Re: DEQ Comments on Siltronic FFS  
Siltronic Corporation  
7200 NW Front Avenue, Portland, OR  
ECSI #183

### **Detailed Response to DEQ's Comments on the Siltronic Focused Feasibility Study**

**March 6, 2008**

**Figure 1**  
 Iron Concentrations in Groundwater  
 RPSA Wells  
 Siltronic Corporation

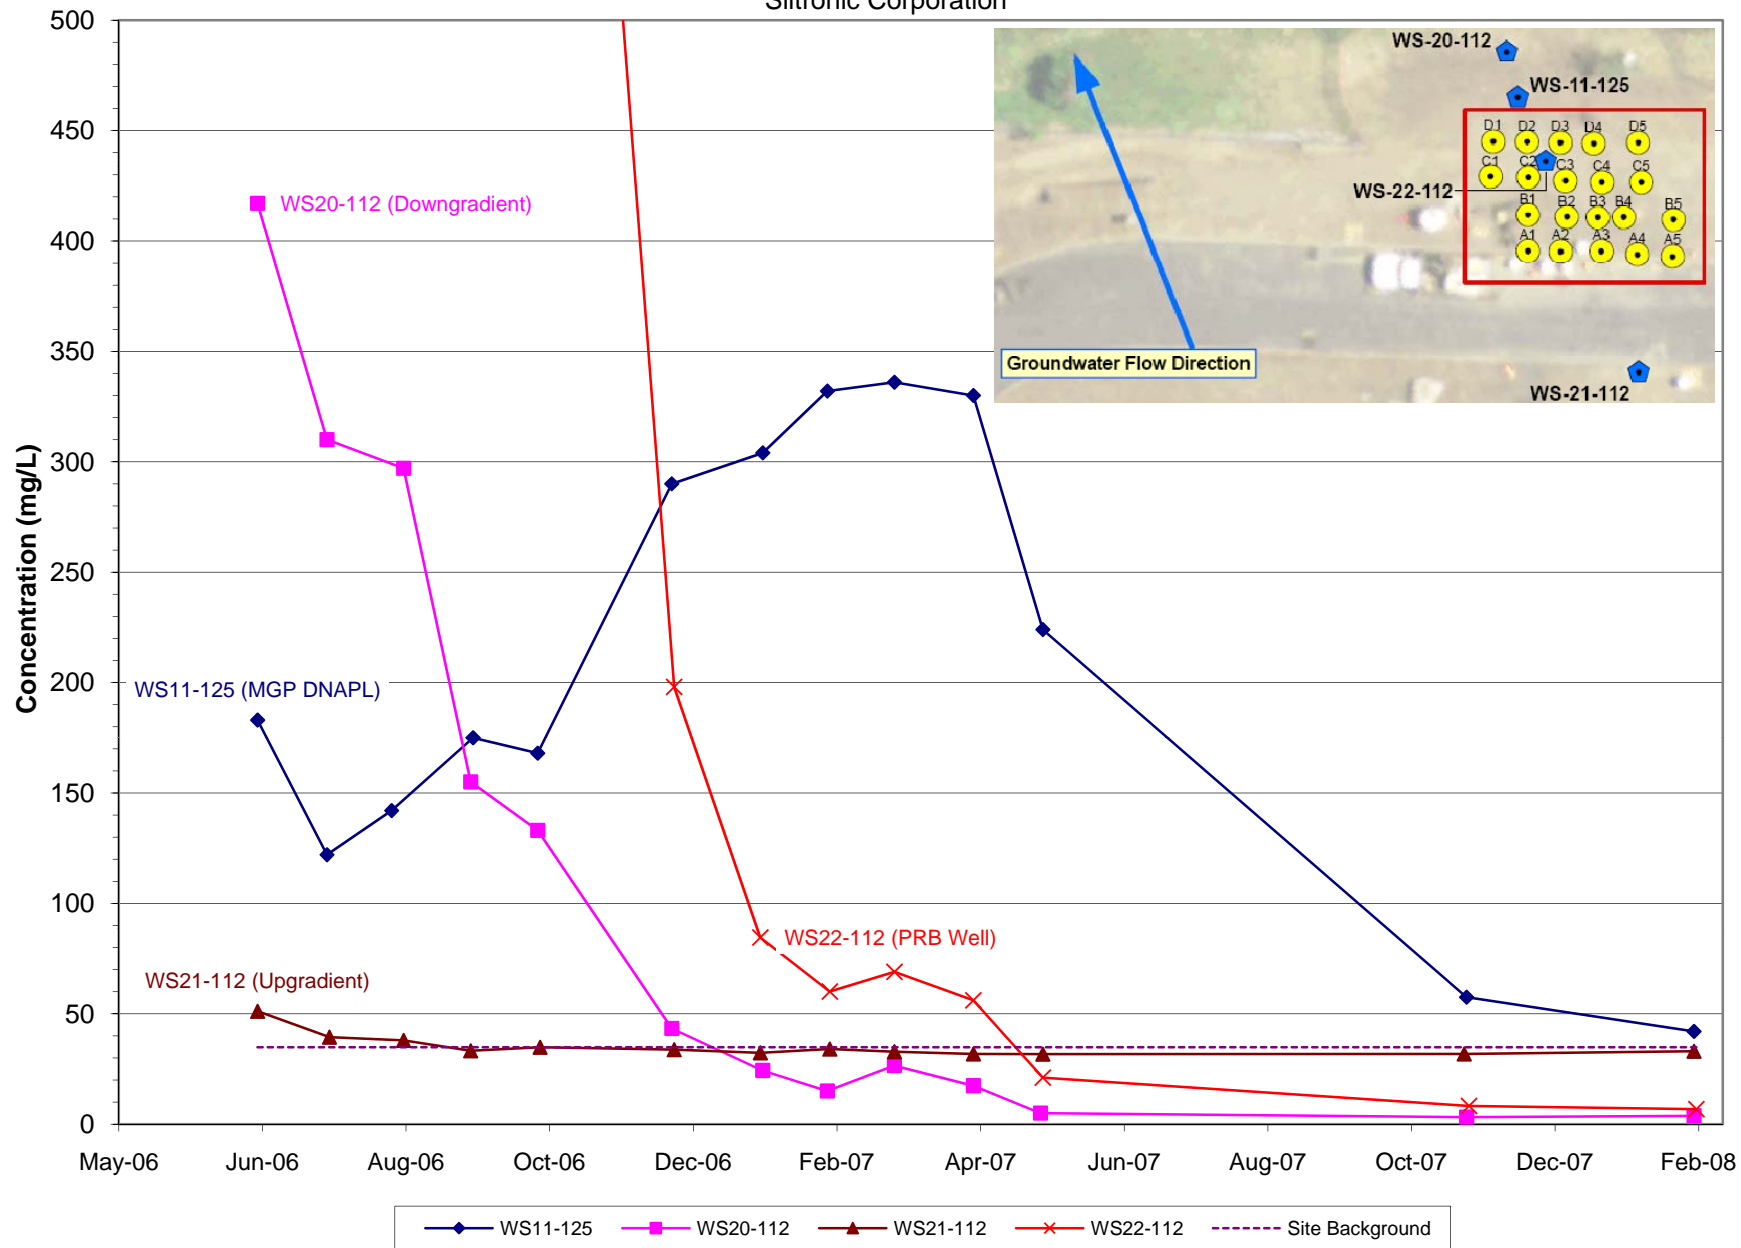
- 23) Page 9. Regarding potential surface water impacts from riverbank EIB implementation, please also see Figure 1. With respect to iron fouling, the Gasco FFS acknowledges that elevated iron concentrations are a concern, and includes contingency pre-treatment for iron in both Segment 1 and Segment 2. DEQ's position that EIB should not be implemented because of an increased risk of iron fouling is inconsistent with their recommendation for groundwater extraction in

- 25) Page 9. DEQ states: “The data suggest to DEQ that iron concentrations have remained elevated at WS11-125, are migrating downgradient, and the reasons (e.g., geochemical, hydrogeological) are not yet understood.” Again, please see Figure 1. With respect to downgradient migration, due to its high reactivity, iron from the EIB PRB is unlikely to migrate in groundwater for significant distances.<sup>2</sup> Elevated iron in WS-11-125 is likely due to enhanced solubility of iron related to chelation by dissolved organic carbon in the form of degraded aromatic structures such as benzene and naphthalene.

Segment 2 (where background iron concentrations are much higher than Segment 1, and are likely to cause fouling). Further, DEQ has not considered that a sheet pile wall is likely to be a source of iron (via oxidation) and resulting fouling. A site-specific evaluation of sheet-pile corrosion rates and resulting increases in iron concentrations should be considered. As previously recommended by Siltronic, a phased approach starting with implementation in Segment 2 to evaluate potential fouling issues (irrespective of EIB impacts) could provide both site-specific fouling data and the time required for sequencing.

**Figure 2**  
cVOCs in Source Area  
PRB Wells WS-19-71/101  
Siltronic Corporation  
Portland, Oregon

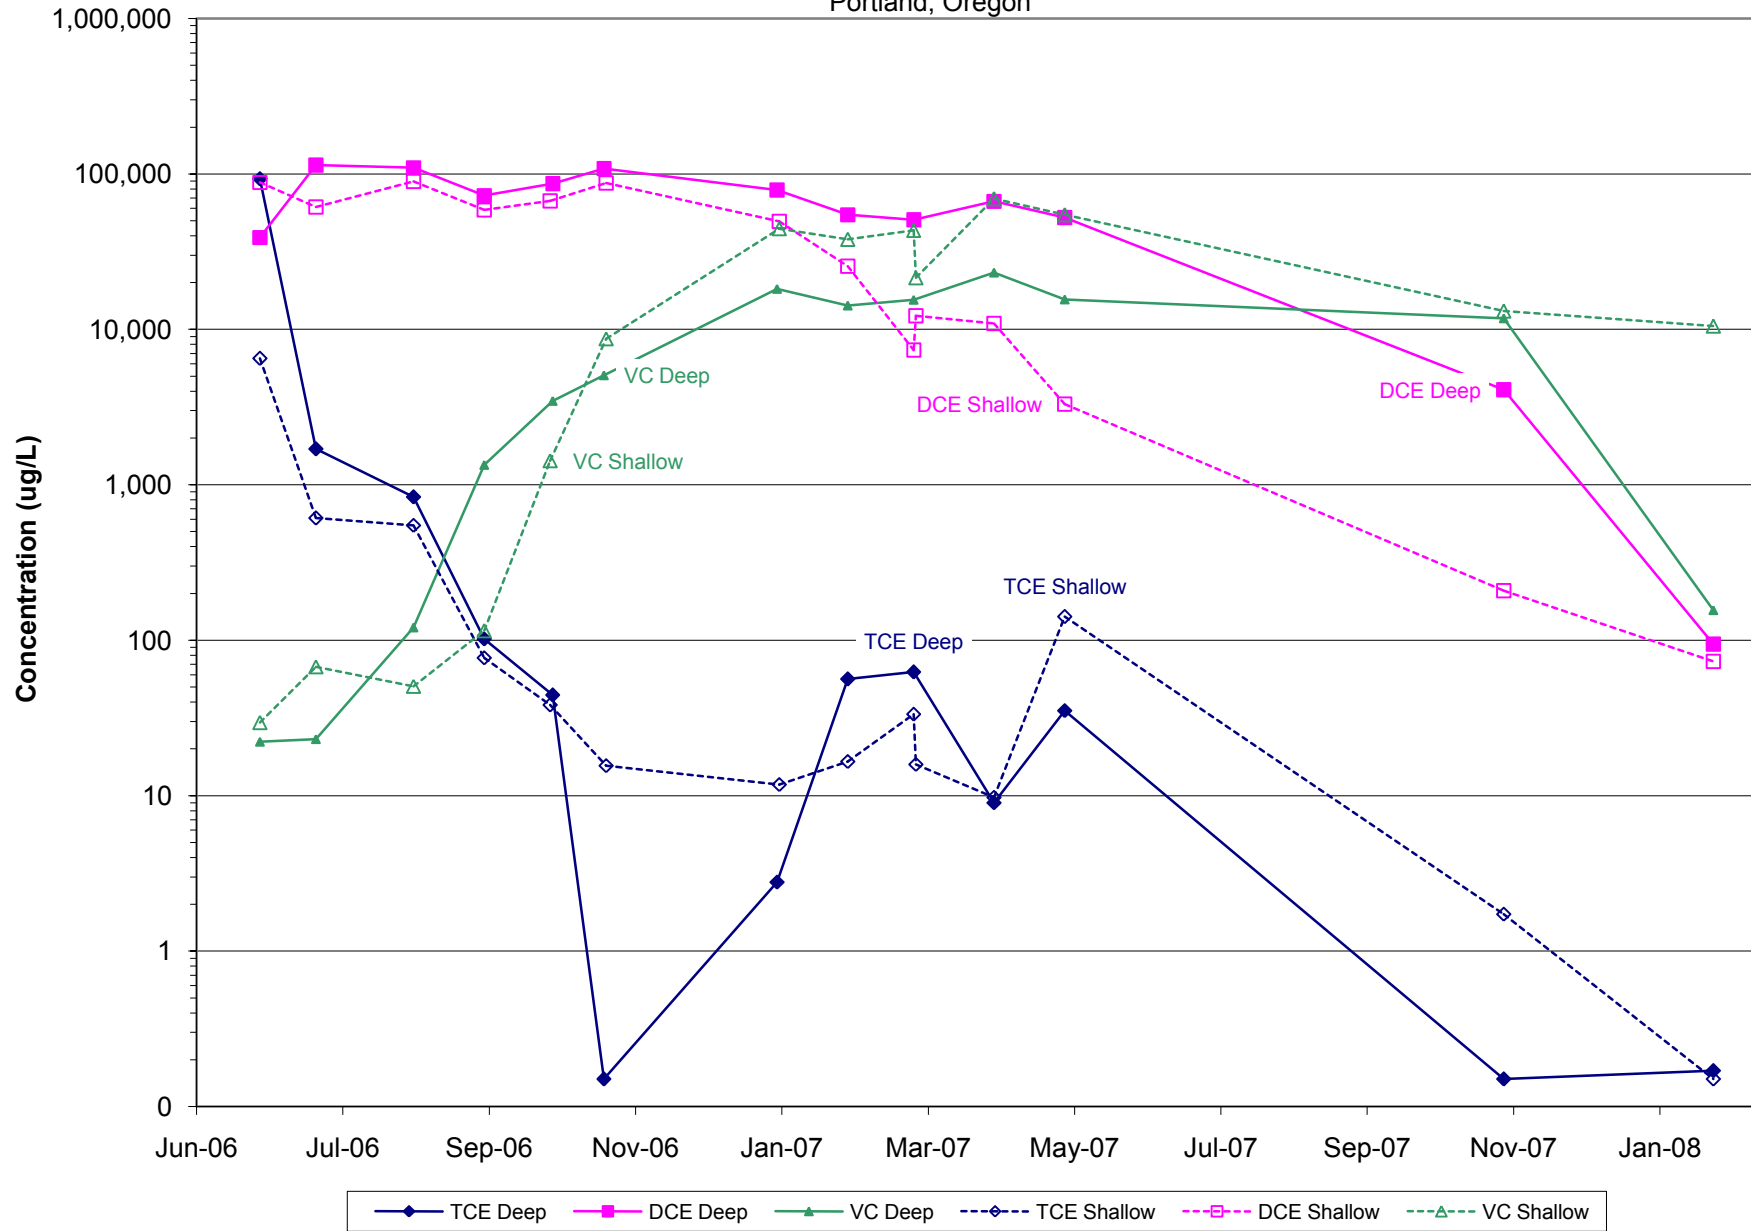
- 32) Page 10. DEQ states: "...concentrations of *cis*-1,2-dichloroethene (*cis*-1,2-DCE) were maintained and vinyl chloride (VC) concentrations increased by orders of magnitude." As shown on the attached Figure 2, concentrations of *cis*-1,2-DCE have significantly declined in the source area PRB wells (WS-19-71/101), by approximately three orders of magnitude. Consistent with the analysis in the Pilot Study Report, vinyl chloride concentrations have begun to decline and will continue to do so.
